SITE PLAN REVIEW AND APPEARANCE BOARD

Meeting: April 28, 2021 | File No: 2020-133-SPF-SPR-CLV | Application Name: Delray Beach CRA Development

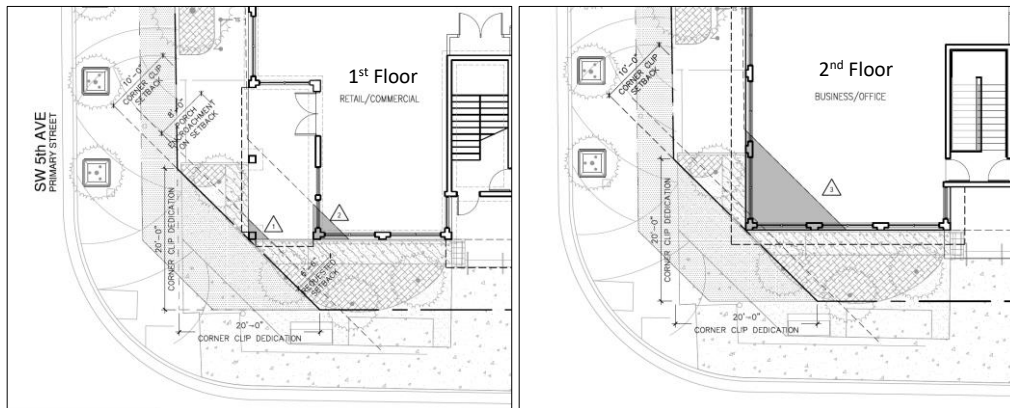
Pursuant to LDR Section 5.3.1 (A)(5), a 20 ft by 20ft "corner clip" right-of-way dedication is required at all intersections in the Central Business District. Dedications are an exaction of a portion of private property for public purposes. The plans provided show the right-of-way dedication at the southwest corner of the property adjacent to the northeast corner of the SW 5th Avenue and SW 1st Avenue intersection. The dedicated area contributes to the minimum 15 ft required streetscape area. Streetscape is composed of a minimum 4 ft curb zone, 6 ft pedestrian clear zone (sidewalk), and remaining front setback area. The plans show the corner clip composed of a public sidewalk width and landscape area which contribute to a minimum 21 feet of streetscape width in this area.

The dedicated area creates a reconfigured property line which creates a “chamfer.” Pursuant to LDR Section 4.4.13 (D)(2)(a)1., and Table 4.4.13 (C), a minimum 10 ft to a maximum 15 ft front setback is required for properties in the CBD. Side lot lines facing streets (SW 1st Avenue) are regulated by front setback requirement. The plans show a minimum 10 ft front setback provided at the front of the property adjacent to SW 5th Avenue and SW 1st Street, but not at the southwest corner of the property which is being dedicated.

If granted, the waiver would not adversely affect the neighboring areas since the relief would not result in any reduction of the minimum required streetscape or diminish the building’s appearance as compared to the surrounding structures. The waiver requests to reduce the minimum 10 ft front setback on the ground floor to 6 ft-6in and 0 ft-0in on the second floor will be located at the southwest corner of the property adjacent to the corner clip dedication area only. The waiver would allow the building to have right angles and maximize the development space while maintaining the minimum 10 ft required front setbacks along SW 5th Avenue and SW 1st Street for the remaining portions of the building. If granted, the waiver would allow the porch to be built to the property line, resulting in a 6ft-6in encroachment which is less than the maximum 8ft allowed for porches in LDR Table 4.4.13 (E). If granted, the waiver would also allow the 2nd story to be built on top of the porch which would have a 0ft-0in front setback.
